\*\*\*\*\*ERRATA SHEET\*\*\*\*\*

THE FOLLOWING CHANGES ARE TO BE MADE TO THE PAGES INDICATED IN THE ASSEMBLY MANUAL. BE SURE TO READ THESE OVER CAREFULLY.

## 8800 GROUNDING MODIFICATION

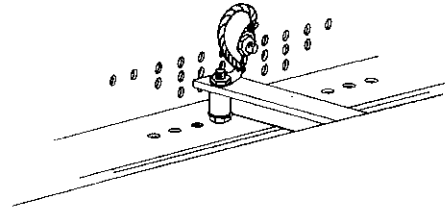
The first connection is to be made between the display/control board and the chassis.

- ( ) Cut a length of the 1/8 inch braid approximately 3 inches and solder a solder lug in place on each end.
- ( ) Referring to the drawing below, attach the braid between the 7805 mounting screw on the back side of the display/control board and the chassis as shown.

NOTE: At any point where a connection is made to the chassis, first rub the area around the connection point with sandpaper or some other abrasive to remove the anodizing.

This connection should be insulated using heat-shrink or some other such tubing.

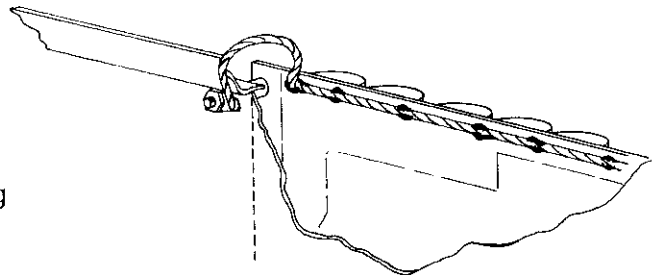
- ( ) Prepare another length of 1/8 inch braid in exactly the same manner as the first piece.
- ( ) Connect this braid between the card rail towards the back of the unit on the side opposite the transformers and the chassis as shown in the drawing below.

- ( ) The 1/4 inch braid is to be soldered directly to the PC land on the bottom (non silk-screened) side of the power supply board. Solder this braid in place along its entire length between the negative side of C1 and the positive side of C14. (see drawing below)
- ( ) Prepare a 4 inch length of 1/8 inch braid by attaching a solder lug to one end.
- ( ) Solder the end opposite the lug on the 4 inch length to the end of the 1/4 inch braid beneath capacitor C1 as shown in the drawing below. The end of the 1/8 inch braid with the solder lug will be attached to the bottom side of the cross member with the same screw which mounts the closest corner of the power supply board.

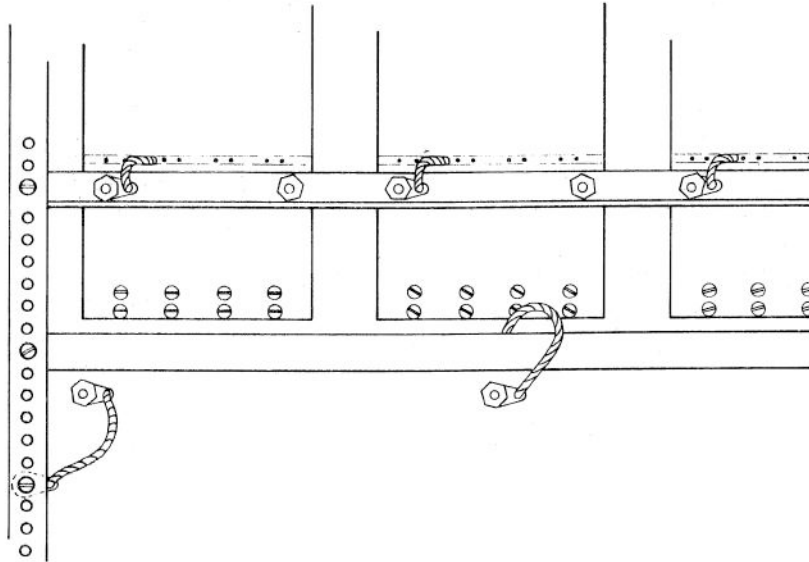
- ( ) Prepare another 3 inch length of 1/8 inch braid by attaching solder lugs to each end.
- ( ) Connect this length of braid between the cross member on the side opposite the transformers and the chassis as shown in the drawing below.

**NOTE:** The drawing below also shows the 4 inch length of braid from the power supply board properly attached to the cross member as previously instructed.
